SENIOR CANYON MUTUAL WATER COMPANY
Ojai, California

FEMA Funding Facilities Repair Service Area Pipeline F2 – Nightingale Pipeline Project

ADDENDUM NO. 1

April 25, 2025

SITE PLAN

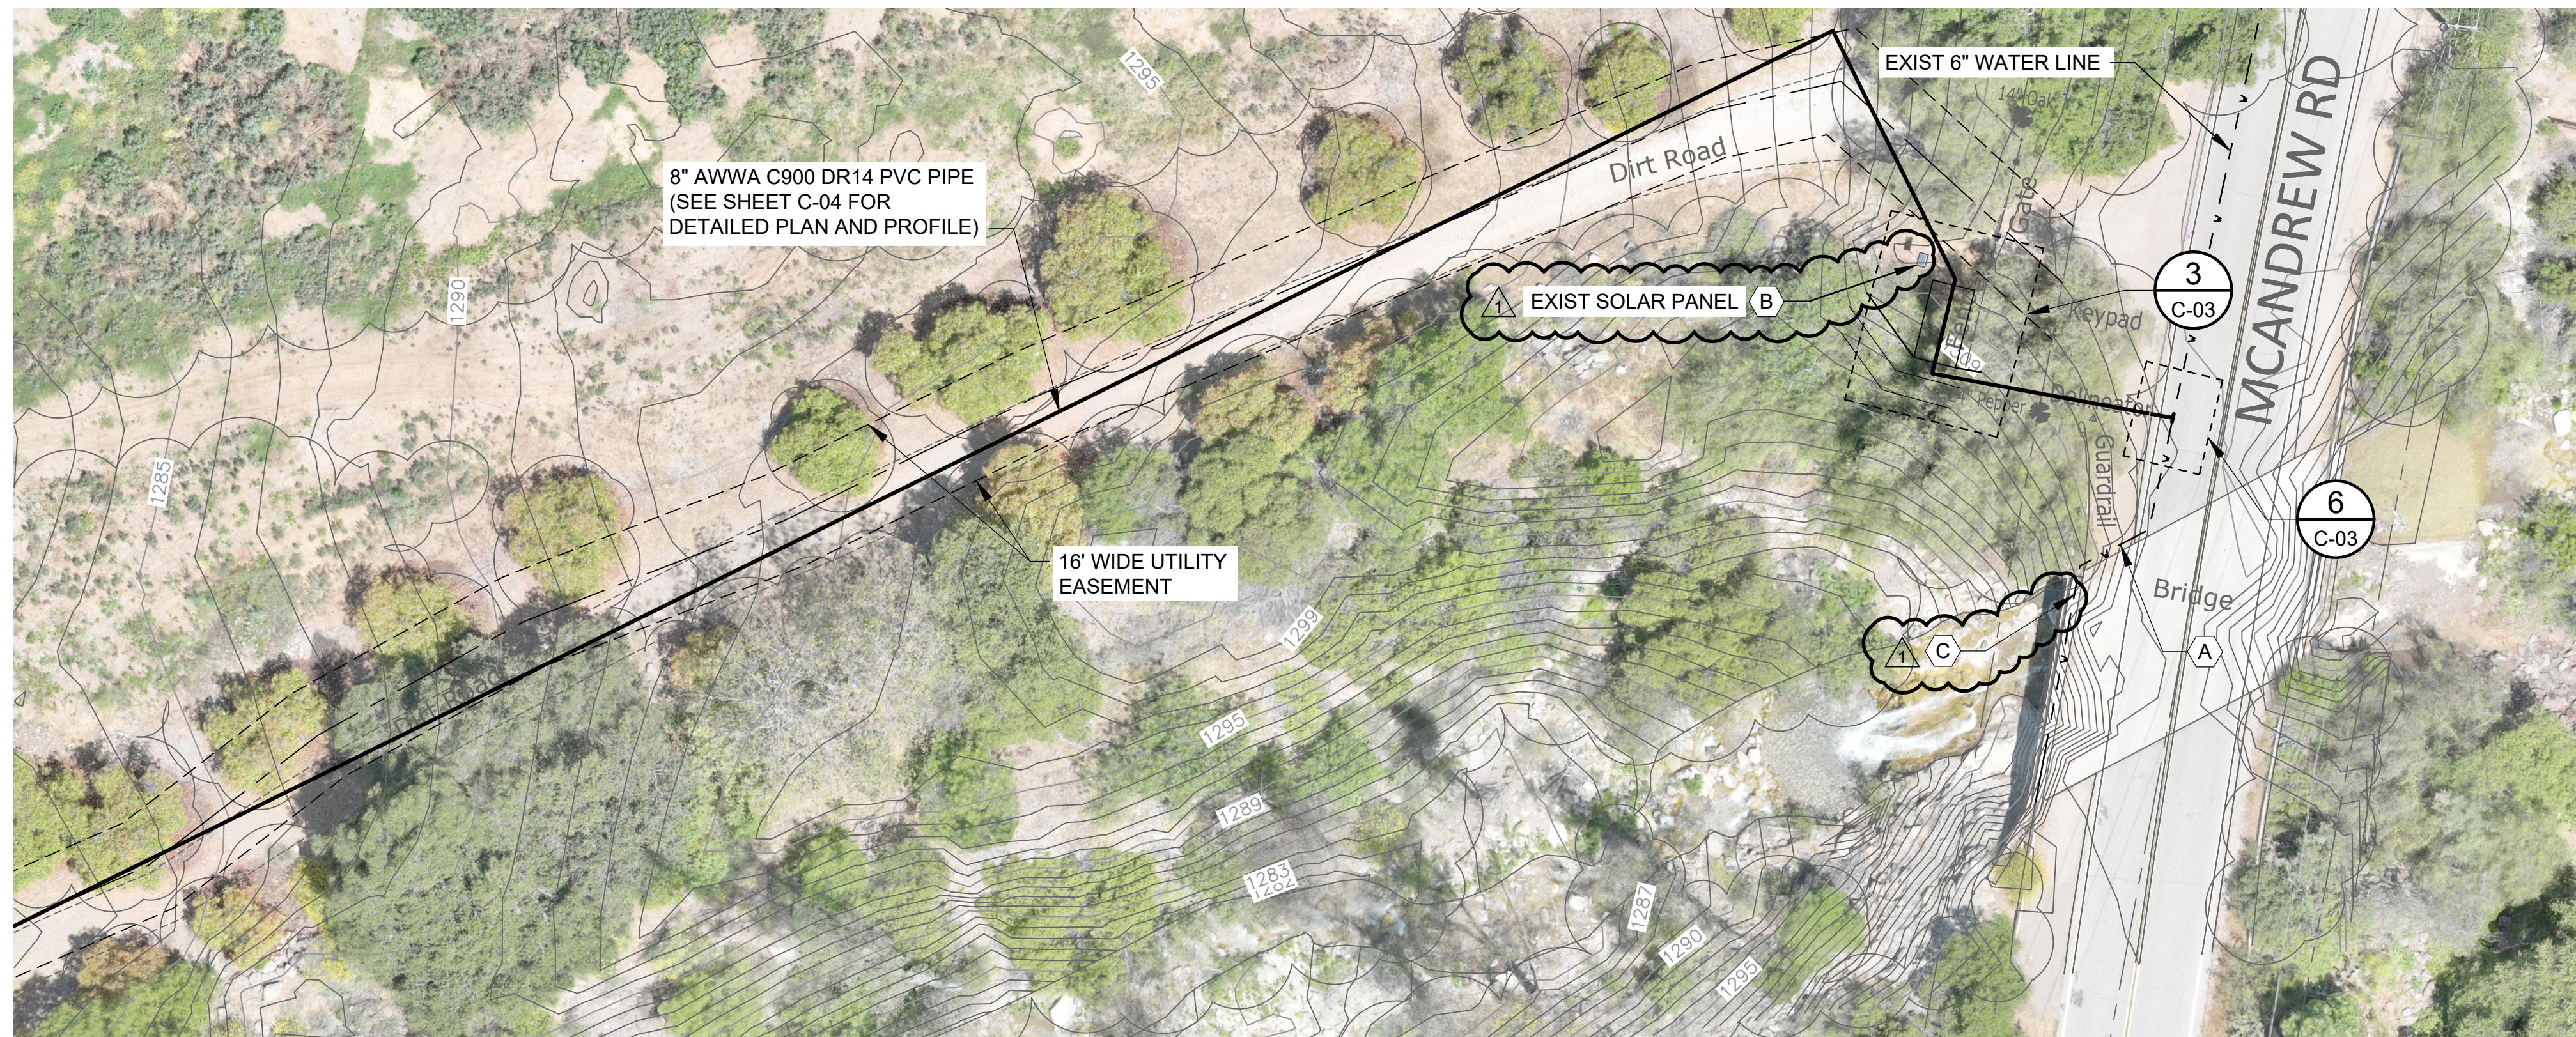
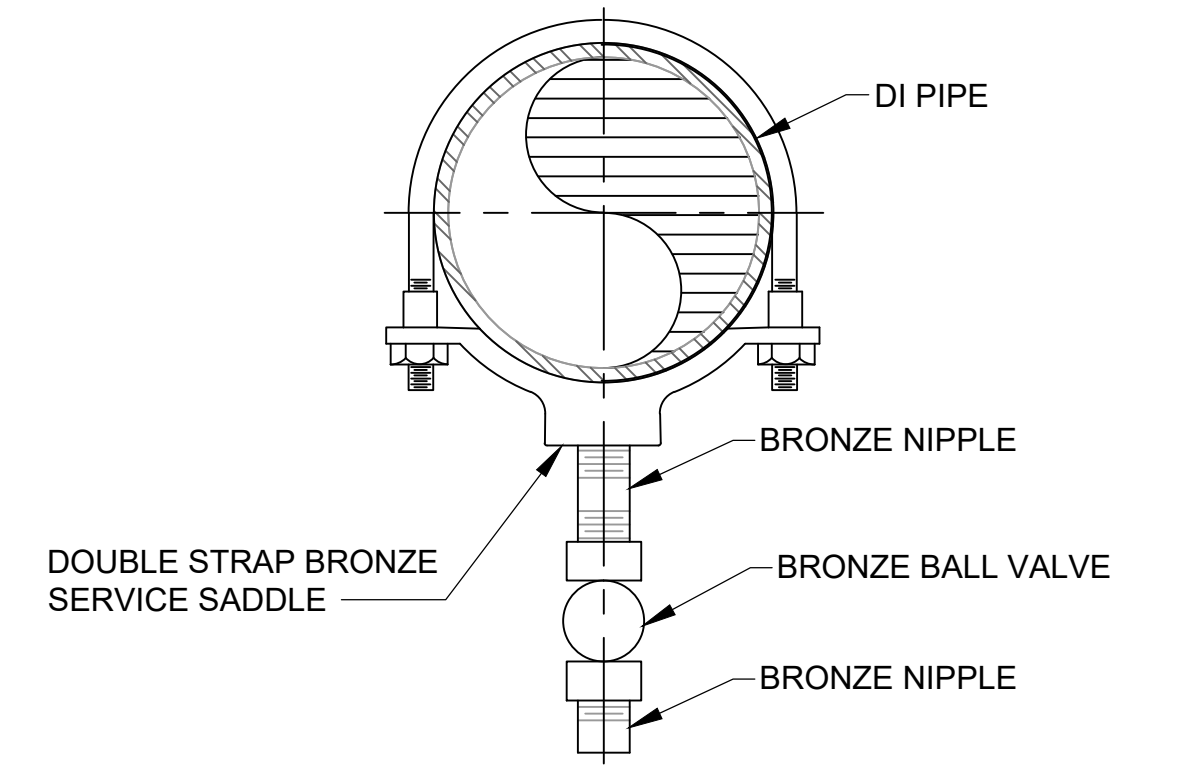
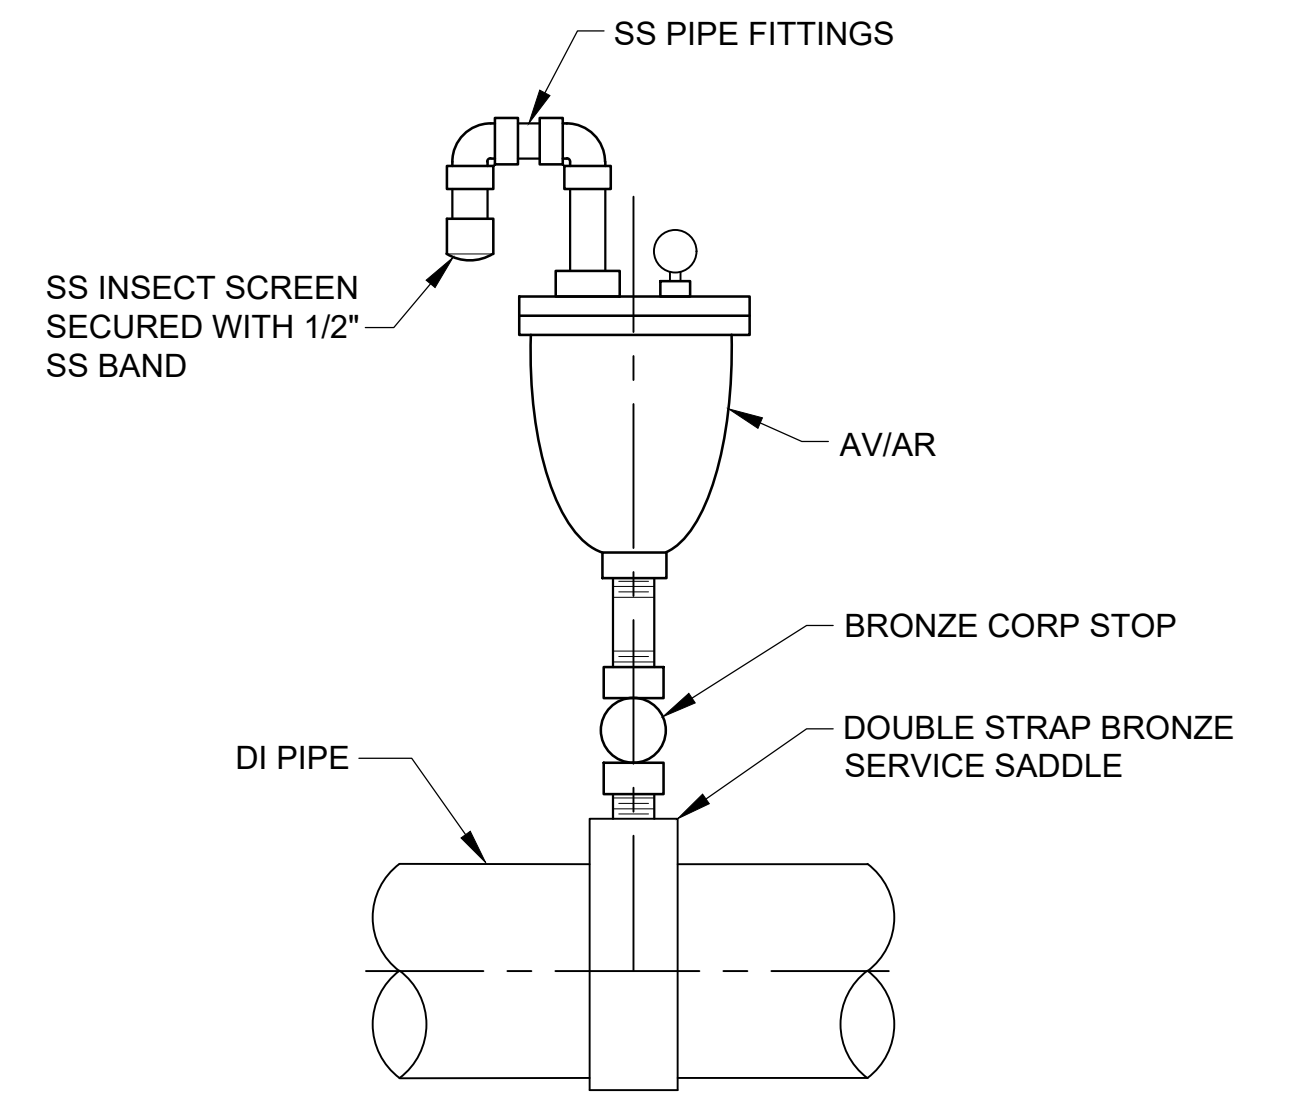
Item AD1-10 Replace Drawing C-01 in its entirety with the revised Drawing C-01 dated 04-2025, attached.

- A. THE EXISTING PIPELINE IN MCANDREW SHALL BE REPLACED FROM THE NEW TEE TO WHERE THE PIPE DAYLIGHTS BEFORE CROSSING THE BRIDGE (APPROXIMATELY 17 LF OF NEW DR14 PVC) AND APPROXIMATELY 60 LINEAL FEET NORTH FROM THE NEW TEE (APPROXIMATELY 60 LF OF NEW DR14 PVC). THE NEW REPLACEMENT PIPE SHALL MATCH THE EXISTING PIPELINE DIAMETER. IT SHOULD BE ASSUMED THAT THE EXISTING PIPELINES TO BE REPLACED ARE 6" IN DIAMETER. AT THE END OF THE 60 LF STRETCH OF REPLACEMENT, INSTALL A NEW BURIED 6" GATE VALVE BEFORE TYING INTO THE EXISTING PIPELINE. GATE VALVE SHALL BE FLANGED BY RESTRAINED MECHANICAL JOINT CONNECTIONS TO EXISTING PIPELINES SHALL BE MADE WITH RESTRAINED FLANGED COUPLING ADAPTERS. IF THE EXISTING PIPELINE IS LESS THAN 6" IN DIAMETER, A CREDIT CHANGE ORDER SHALL BE PROVIDED FOR THE PIPELINES AND APPURTENANCES.

- B. RELOCATE THE SOLAR PANEL POLE AND CONDUIT FOR THE GATE AS NEEDED TO CONSTRUCT THE PRV STATION AND PIPELINE. RELOCATED POSITION TO BE FIELD LOCATED WITH SENIOR CANYON STAFF.

- C. CONTRACTOR MAY UTILIZE THE EXISTING 2" AIR/VAC TAP ON THE EXPOSED PORTION OF THE EXISTING 6" PIPELINE ACROSS THE BRIDGE ON MCANDREW RD FOR WATER USE DURING CONSTRUCTION. CONTRACTOR MUST FURNISH THEIR OWN REDUCED PRESSURE BACKFLOW PREVENTOR TO BE INSTALLED AS PART OF THIS CONNECTION. THE REDUCED PRESSURE BACKFLOW PREVENTOR MUST BE USC CROSS CONNECTION CERTIFIED AND TESTED AT THE TIME OF INSTALLATION.

C-02

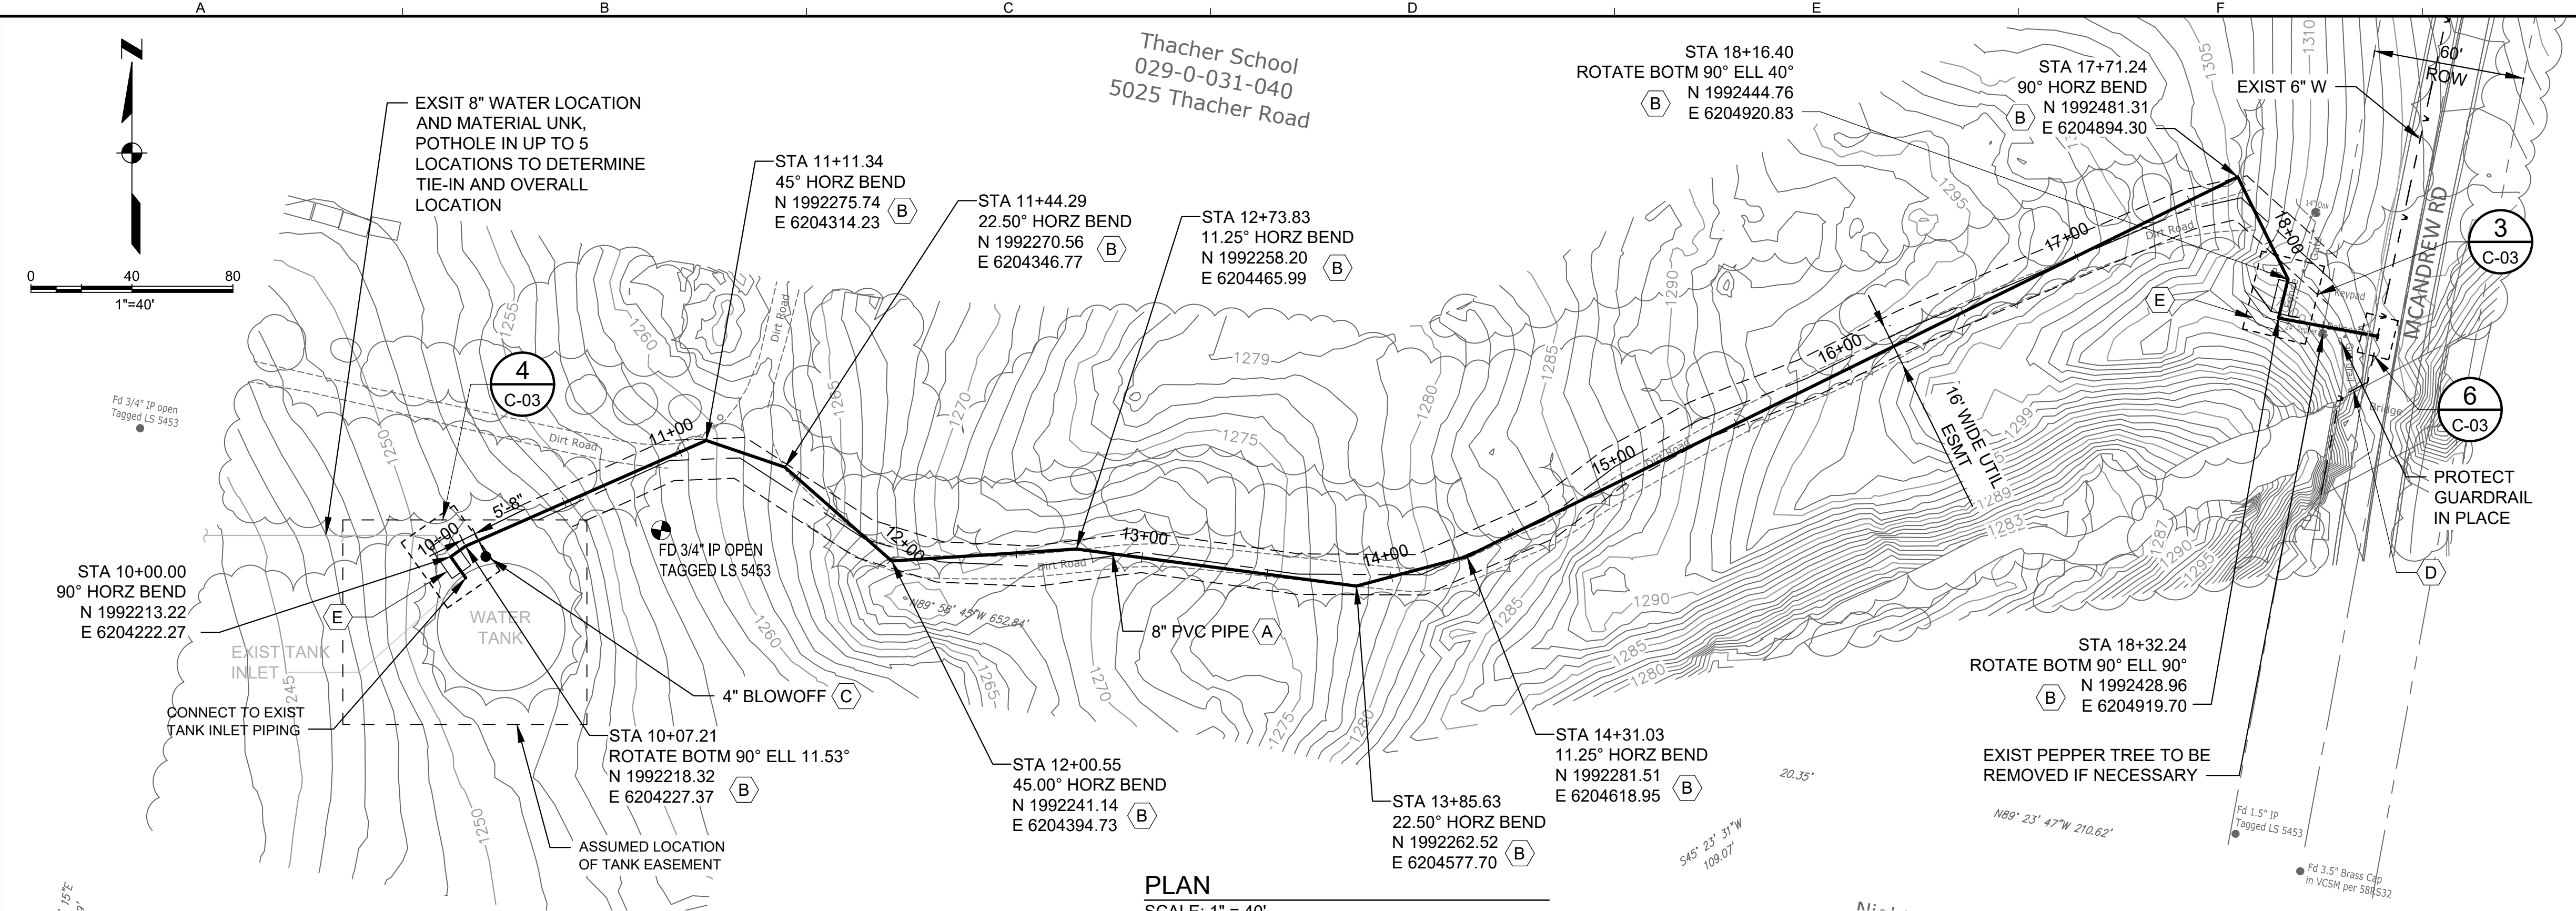
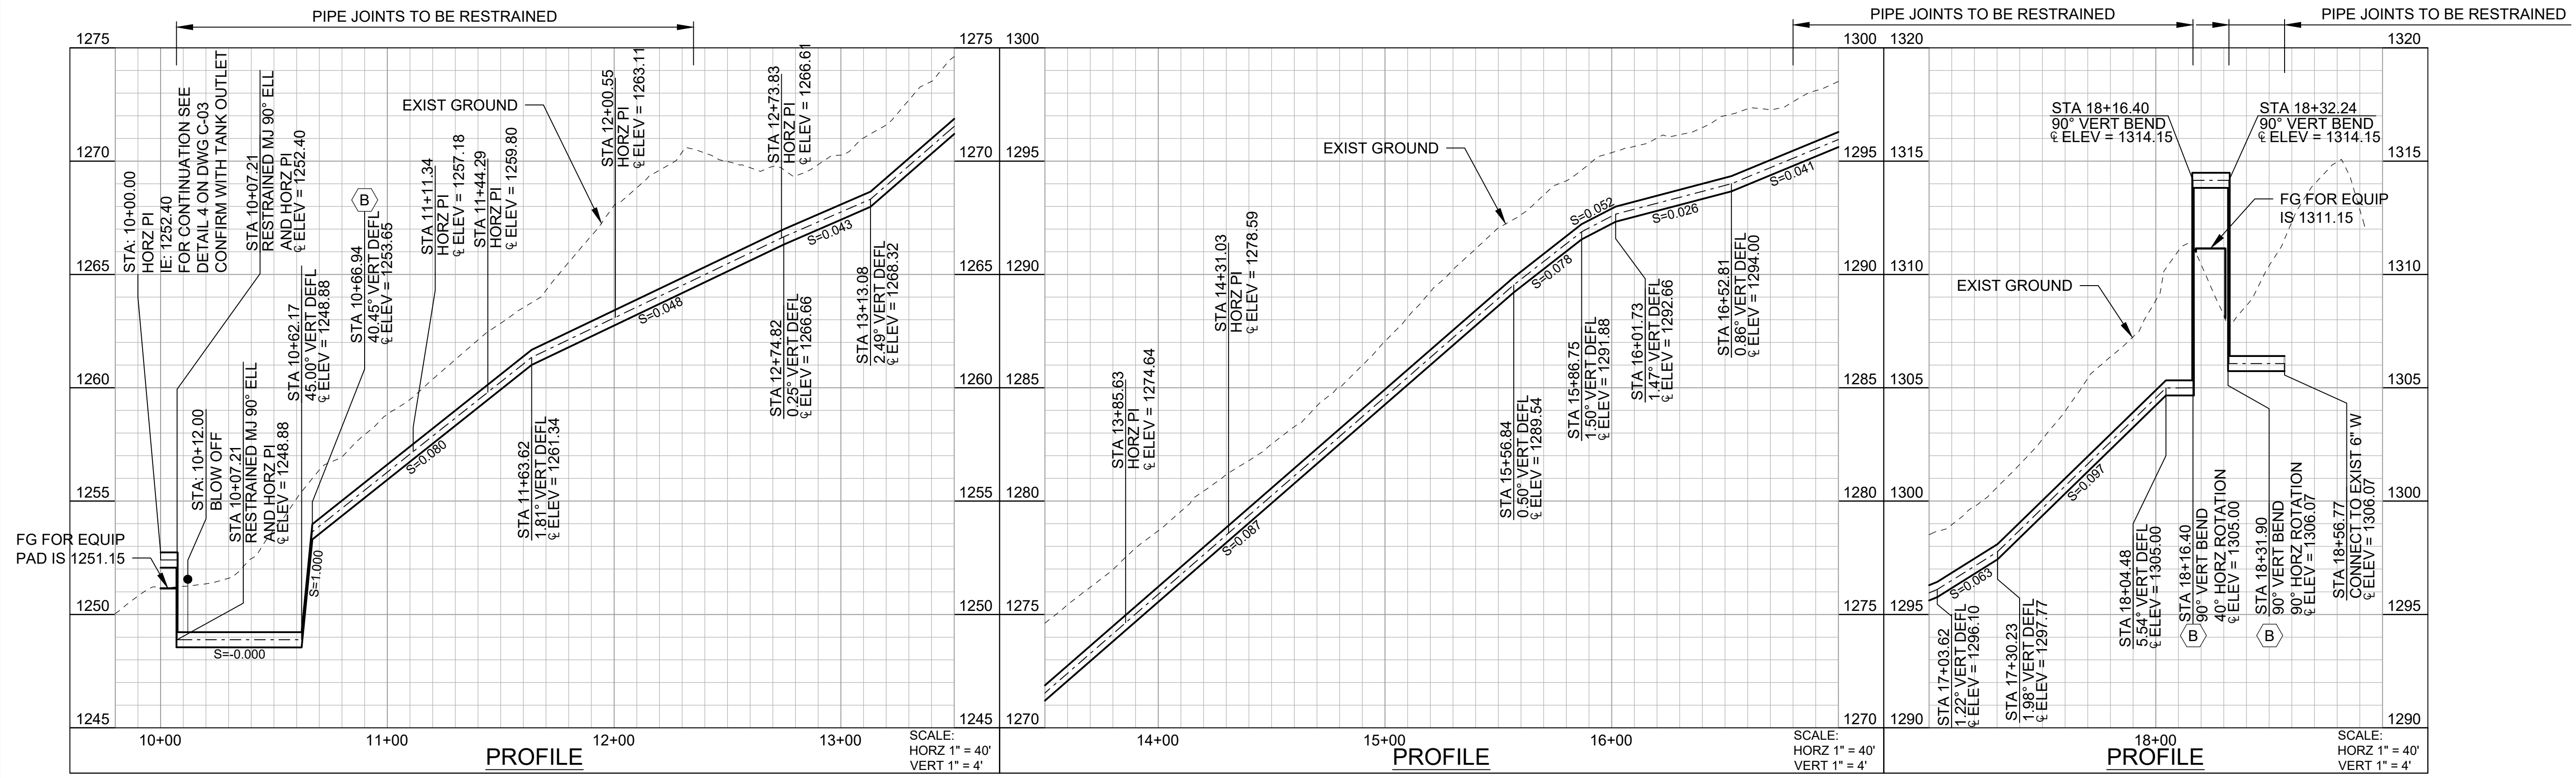
Item AD1-11 Replace Drawing C-02 in its entirety with the revised Drawing C-02 dated 04-2025, attached.

- SHEET KEYNOTES**
- A. INSTALL 8-INCH AWWA C900 DR 14 (PRESSURE CLASS 305) WATERLINE WITH TRACER WIRE AND DETECTION TAPE. TRENCH BACKFILL AND RESTORATION SHALL BE IN ACCORDANCE WITH COUNTY OF VENTURA PUBLIC WORKS AGENCY WATER AND SANITATION CONSTRUCTION STANDARDS DETAIL W-1.

- B. INSTALL DUCTILE IRON FITTING SPECIFIED ON PLANS. INSTALL THRUST BLOCK PER COUNTY OF VENTURA PUBLIC WORKS AGENCY WATER AND SANITATION CONSTRUCTION STANDARDS DETAIL W-19. WITH THE EXCEPTION THAT DEPTH OF COVER TO TOP OF PIPE CAN BE A MINIMUM OF 24".

- C. INSTALL 4" BLOWOFF PER COUNTY OF VENTURA PUBLIC WORKS AGENCY WATER AND SANITATION CONSTRUCTION STANDARDS DETAIL W-10.
 - D. THE EXISTING PIPELINE IN MCANDREW SHALL BE REPLACED FROM THE NEW TEE TO WHERE THE PIPE DAYLIGHTS BEFORE CROSSING THE BRIDGE (APPROXIMATELY 17 LF OF NEW DR14 PVC) AND APPROXIMATELY 60 LINEAL FEET NORTH FROM THE NEW TEE (APPROXIMATELY 60 LF OF NEW DR14 PVC). THE NEW REPLACEMENT PIPE SHALL MATCH THE EXISTING PIPELINE DIAMETER. IT SHOULD BE ASSUMED THAT THE EXISTING PIPELINES TO BE REPLACED ARE 6" IN DIAMETER. AT THE END OF THE 60 LF STRETCH OF REPLACEMENT, INSTALL A NEW BURIED 6" GATE VALVE BEFORE TYING INTO THE EXISTING PIPELINE. GATE VALVE SHALL BE FLANGED BY RESTRAINED MECHANICAL JOINT. CONNECTIONS TO EXISTING PIPELINES SHALL BE MADE WITH RESTRAINED FLANGED COUPLING ADAPTERS. IF THE EXISTING PIPELINE IS LESS THAN 6" IN DIAMETER, A CREDIT CHANGE ORDER SHALL BE PROVIDED FOR THE PIPELINES AND APPURTENANCES.

- E. FINAL LOCATION OF PAD TO BE DETERMINED BY SENIOR CANYON STAFF IN THE FIELD. EXCAVATE MINIMUM 2' BENEATH PAD AND RECOMPACT WITH NATIVE SOIL, AS DEFINED IN SPECIFICATION SECTION 02300. IN 6" LIFTS TO 95% RELATIVE DENSITY. REGRADE THE AREA AS NEEDED WITH COMPACTED FILL TO 95% RELATIVE COMPACTON. MAX SLOPE SHALL BE 2:1.
